## **PLAN REVIEW SHEET**

2013-047

Brookline Residential, LLC Email:

**Concrete Pad Spec**

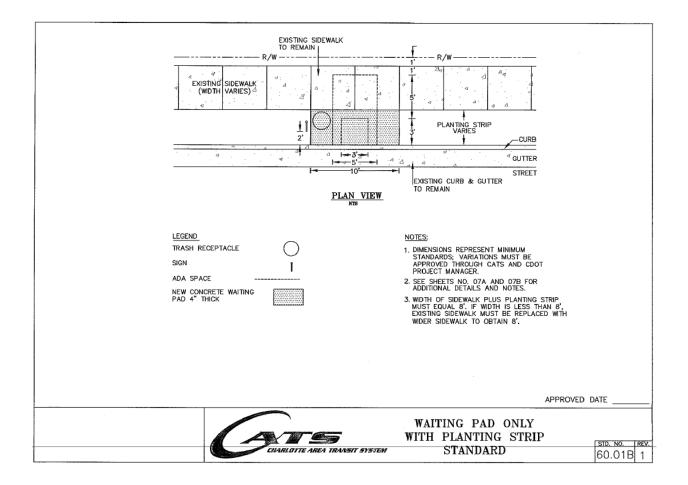
We request that the Petitioner provide waiting pads for bus service along Reames Road. The new pads would be located either side of Reames Road to provide residents with service in each direction to both Uptown and Northlake Mall. A pedestrian refuge island near the northern edge of the properties is also requested to help residents cross the street between apartments either side of Reames Road.

The concrete waiting pads would be located between the existing curb and the new sidewalk. Pad must be flush with sidewalk and level within 2% when measured perpendicular to street for compliance with the ADA. Below is an image of the standard (60.01B) detail for the two requested pads.
